Access Compliance Report

Public Rights-of-Way

(Curb Ramps)

Intersection ID: 13641	Main Street: BAY_ST	Cross Street: CLEMENT_AV	Location: S
ADA ID: 1A2443B4E94E	Ramp Type: PerpDiag	Initial Pass/Fail: Fail	Overall Compliance: No
		Severity Score: 12.5

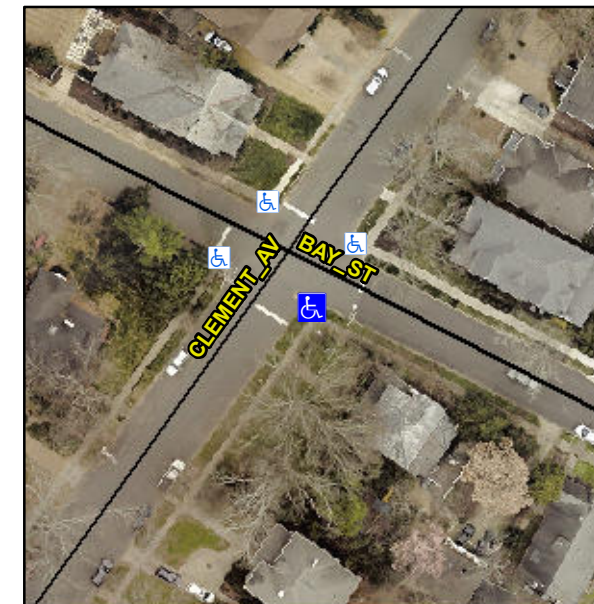
Not Found, R304.2.2

Compliance	Description	Data	Compliance	Description	Data
N/A	Ramp Length (in)	51.0	No	Ramp Slope (%)	10.6
Yes	Ramp Width (in)	63.0	Yes	Ramp XSlope (%)	0.8
N/A	Flare Type LT	N/A	N/A	Flare Type RT	N/A
N/A	Flare Slope LT (%)	N/A	N/A	Flare Slope RT (%)	N/A
N/A	Flare Traversable LT?	N/A	N/A	Flare Traversable RT?	N/A
N/A	Landing Length (in)	N/A	N/A	DWS Provided?	N/A
N/A	Landing Width (in)	N/A	N/A	DWS Contrast?	N/A
N/A	Landing Slope (%)	N/A	N/A	DWS Length (in)	N/A
N/A	Landing X Slope (%)	N/A	N/A	DWS Full Width?	N/A
N/A	Landing Curb? (Y/N)	N/A	N/A	DWS Offset (in)	N/A
N/A	Shared Landing?	N/A			
N/A	Gutter Ponding?	Yes	N/A	Gutter Slope (%)	N/A
N/A	Gutter Lip Ht (in)	N/A	N/A	Gutter X Slope (%)	N/A
N/A	Painted X Walk1?	No	N/A	Painted X Walk2?	No
	X Walk 1 Direction	To NE		X Walk 2 Direction	To NW
N/A	X Walk 1 Width (in)	N/A	N/A	X Walk 2 Width (in)	N/A
	X Walk 1 Slope (%)	4.7		X Walk 2 Slope (%)	2.9
	X Walk 1 X Slope (%)	1.9		X Walk 2 X Slope (%)	2.3

Remove & Replace Curb Ramp With Two New Directional Ramps or Equivalent.
